Addendum

Iowa Department of Transportation Date of Letting: April, 19, 2016

Date of Addendum: March 30, 2016

B.O.	Proposal ID	Proposal Work Type	County	Project Number	Addendum		
102	16-0382-037	PCC PAVEMENT - REPLACE	CEDAR	STP-038-2(37)2C-16	19APR102.A01

TABULATIONS

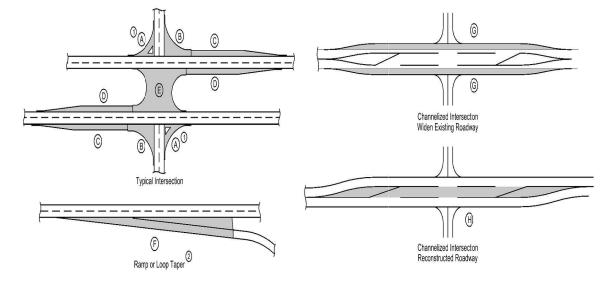
Sheet C.7 – HMA Pavement Tabulation Updated due to incorrect tabulations.
